RE: **Blythe Solar Power Project, Docket No. 09-AFC-6**
Responses to January 14, 2010 CEC Workshop Queries
Technical Areas:
Soil & Water Resources (supplemental data for DR-S&W-218)

**Soil and Water Resources
(Supplemental Data for DR-S&W-218)**

Blythe Solar Power Project
Docket No. 09-AFC-6

Soil and Water Data Responses to January 14, 2010 CEC Workshop Queries

2008-045-CP-005

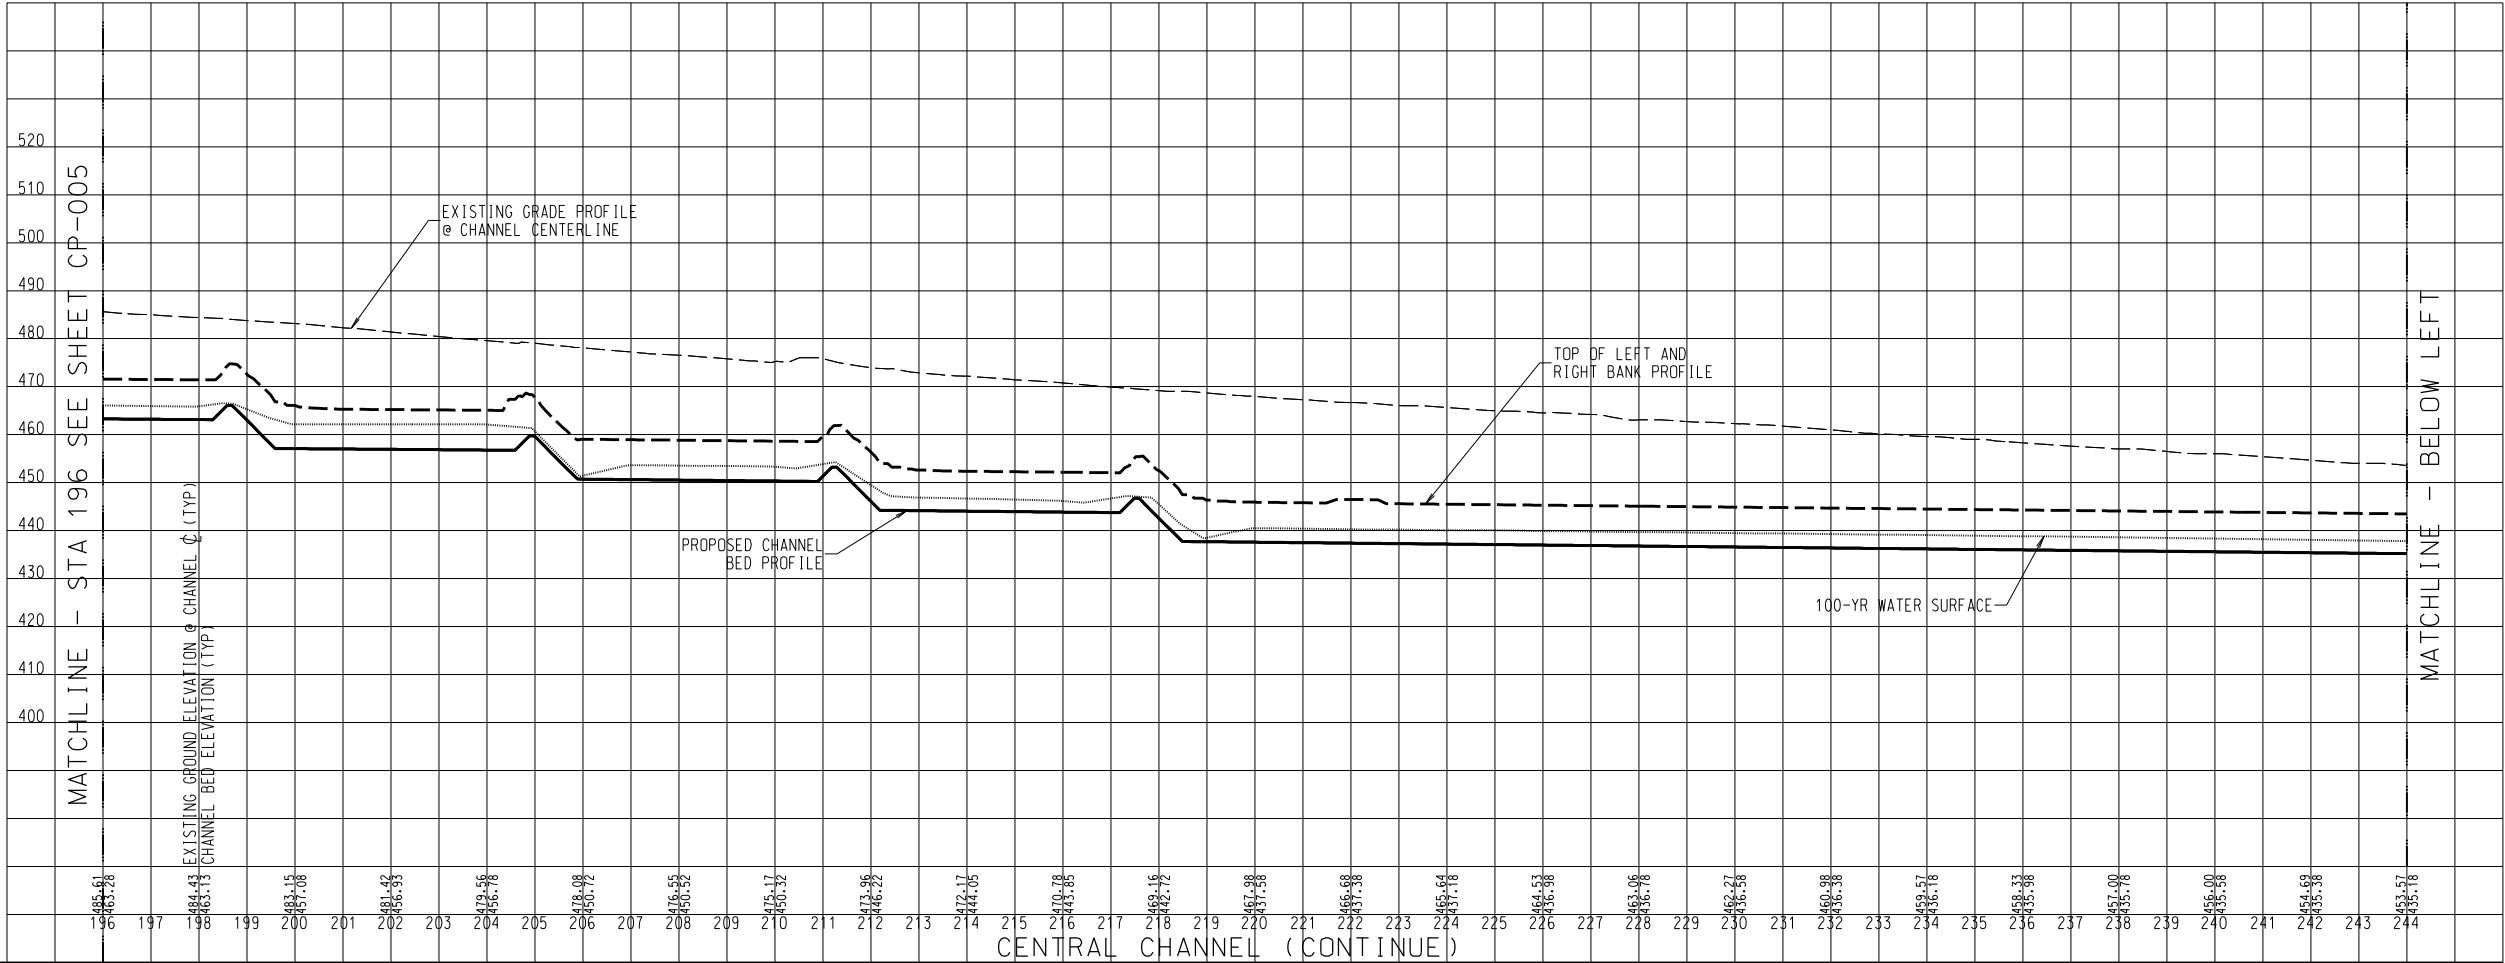
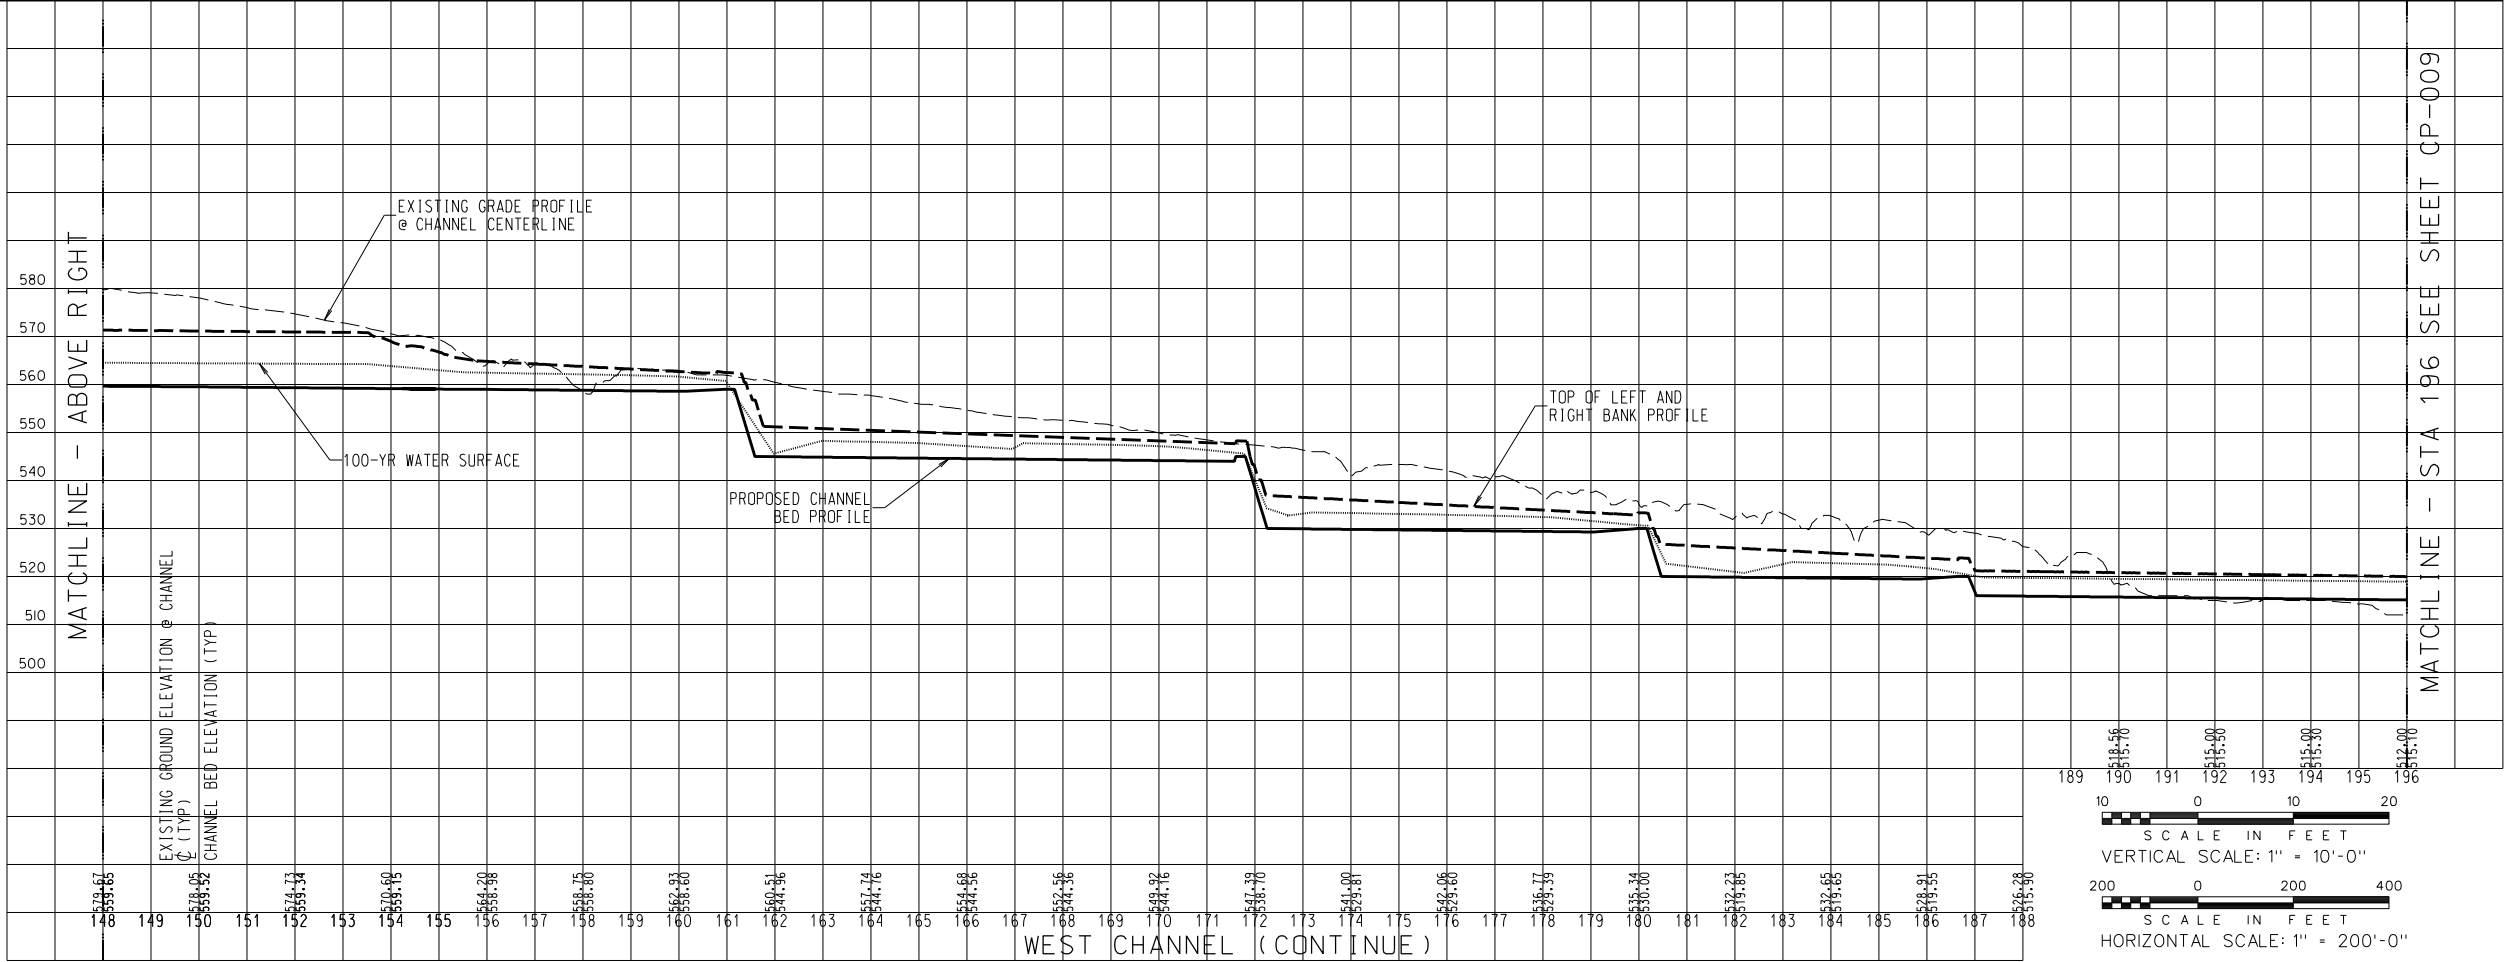
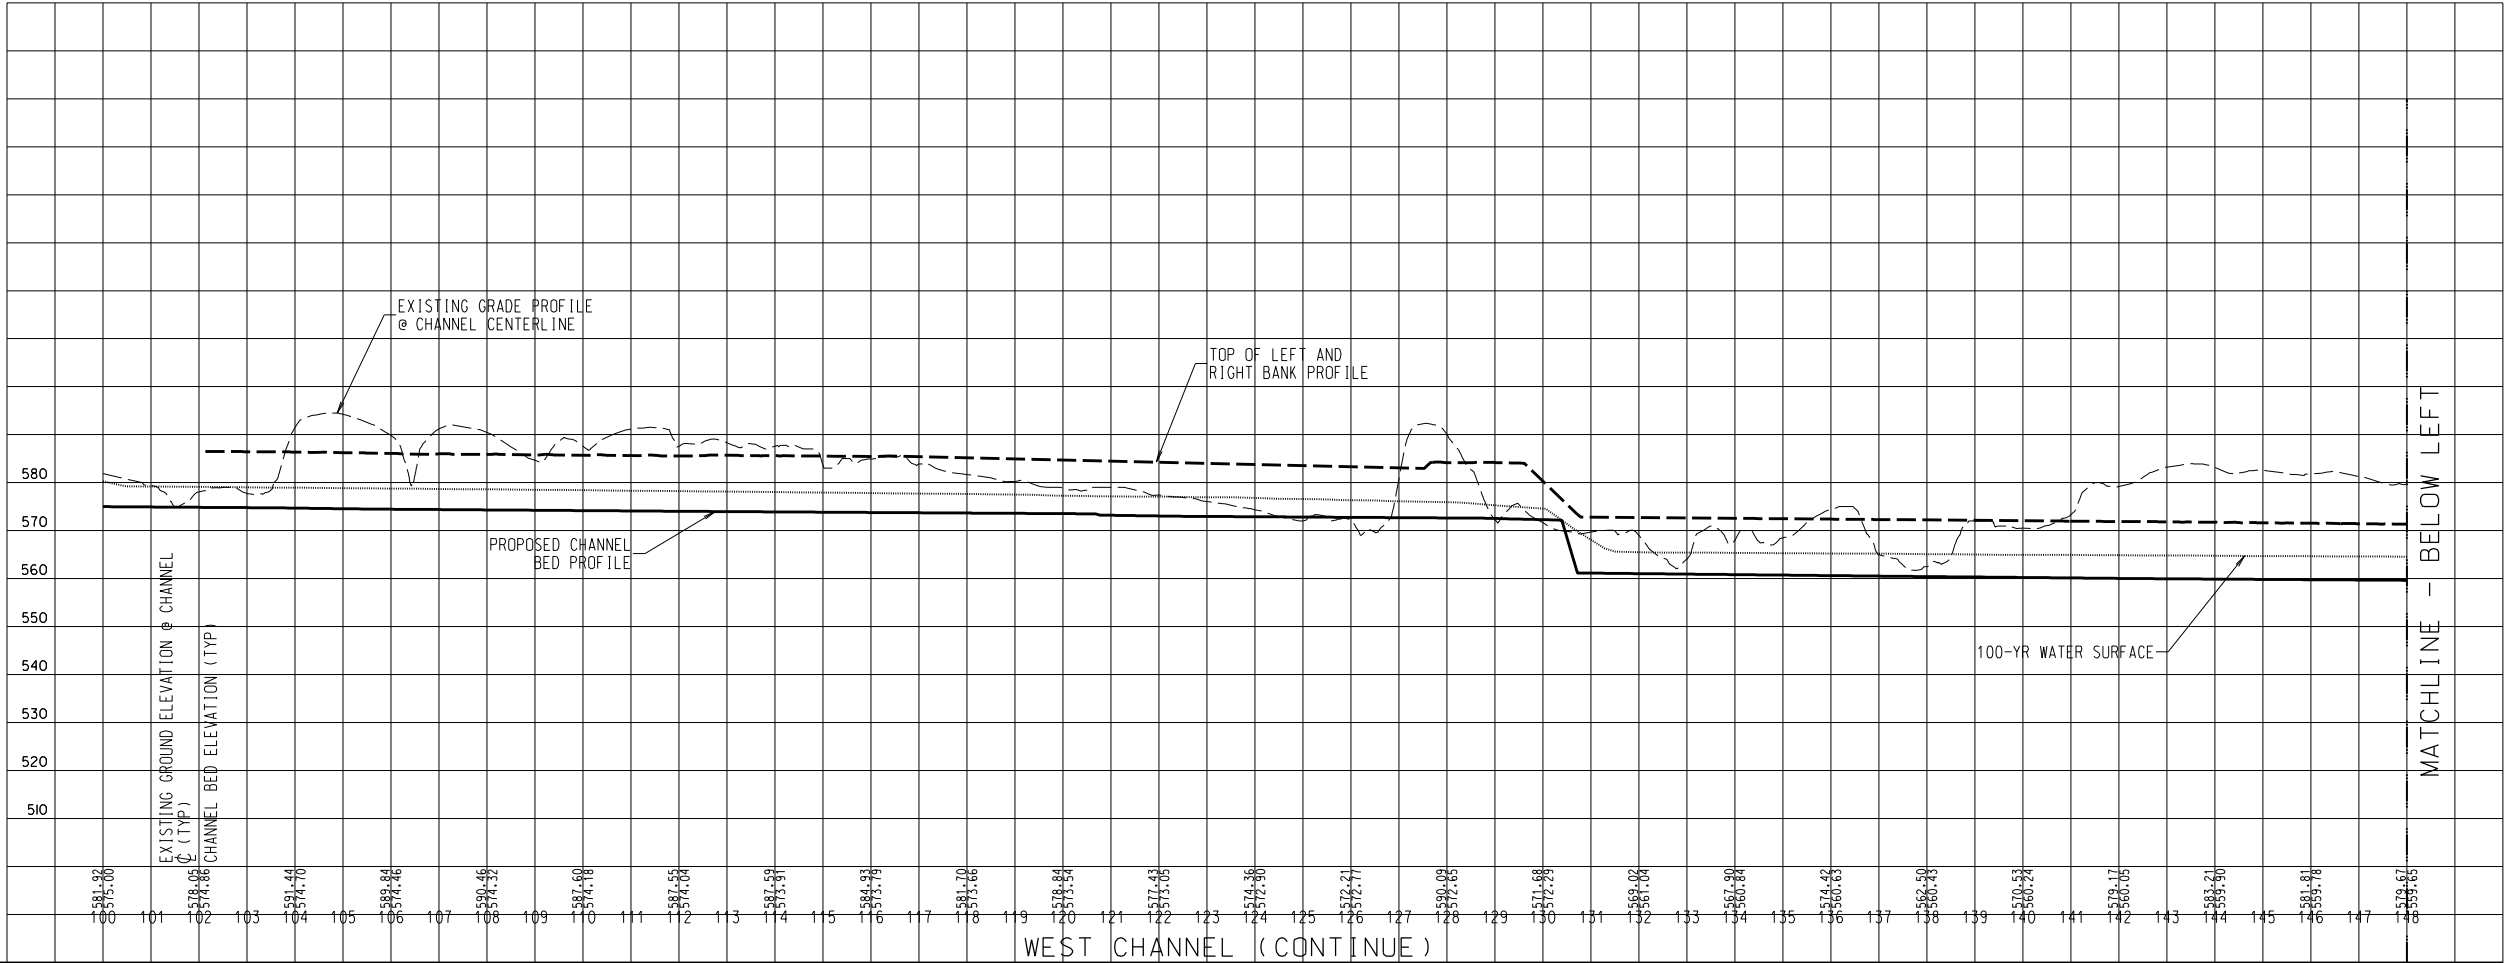
Add 100-yr. water surface elevations on profiles for main channels (both collectors and conveyance).

The 100-year water surface profile has been added to the plans and is provided on Sheets CP-001 to CP-009 as part of this response.
